SUBJECT: FORWARDS RESPONSES TO ROUND ONE, SET THREE QUESTIONS FROM  
 AUXILIARY SYS BRANCH. RESPONSES WILL BE INCORPORATED IN FSAR.

Subject: WPPSS NUCLEAR PROJECT NO. 2  
RESPONSES TO ROUND ONE  
QUESTIONS, SET THREE - ASB

Auxiliary Systems Branch Questions  
(10.10 - 10.34)

FIGURE  
9.2-8

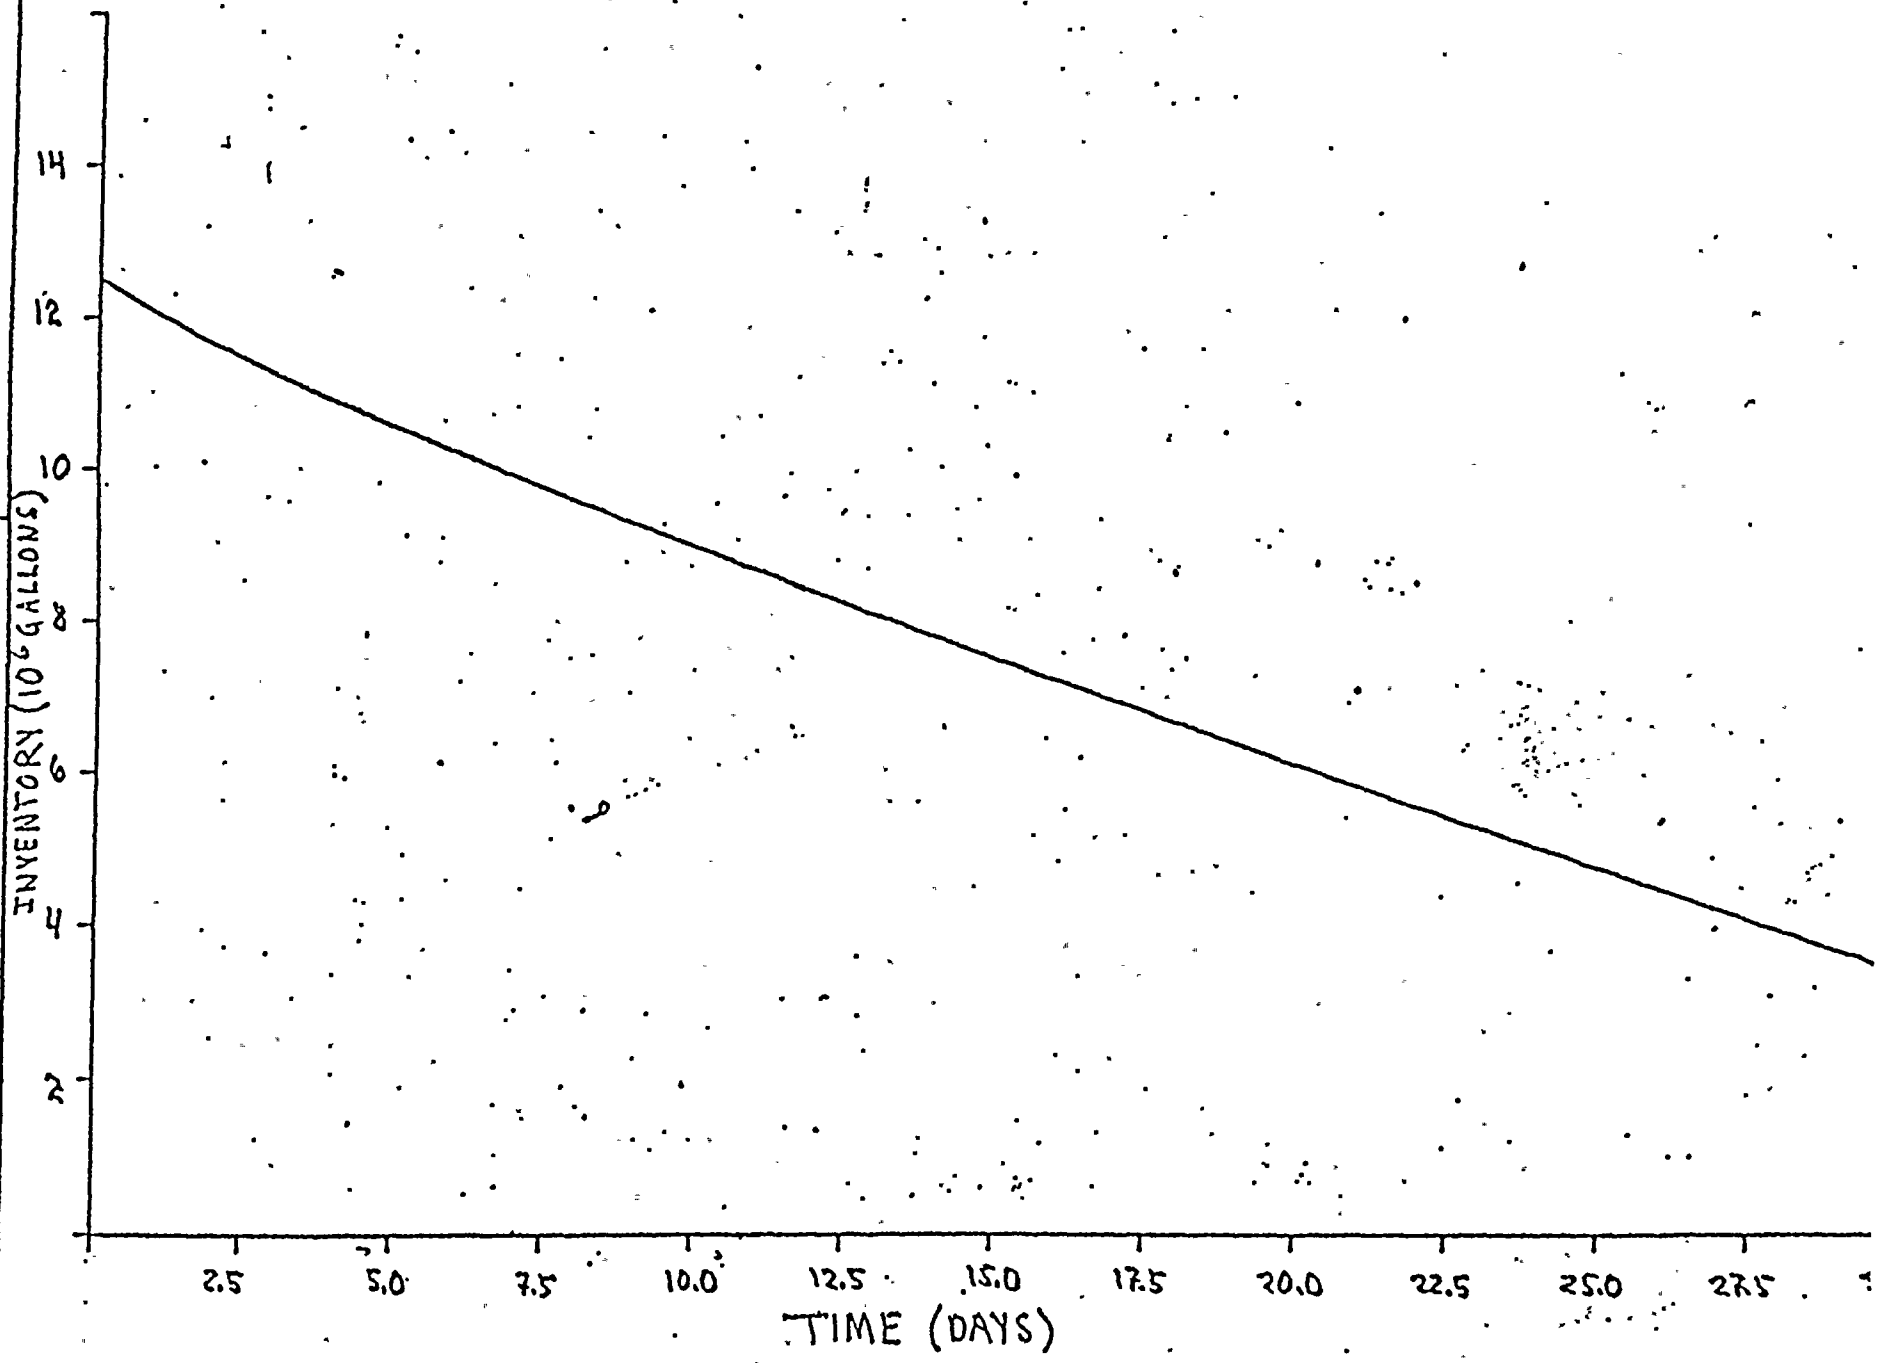
Provide the results of your analysis of the capability of the ultimate heat sink to absorb heat over a thirty-day period following a postulated design basis accident. Indicate the total heat absorbed in the ultimate heat sink, including the sensible heat, the station auxiliary system heat, and the decay heat released by the reactor core. In particular, provide the following information in both tabular and graphical formats:

See revised Section 9.2.5\* which provides the revised results of the analysis including the information requested above. This revision also addresses the concerns of Question 371.6.

The results of the mass loss analysis assuming an unfouled heat exchanger is shown in Figure 9.2-8 and is tabulated in Table 9.2-3. The mass loss assuming a fouled heat exchanger is less severe, but only by approximately 2,000 gallons.
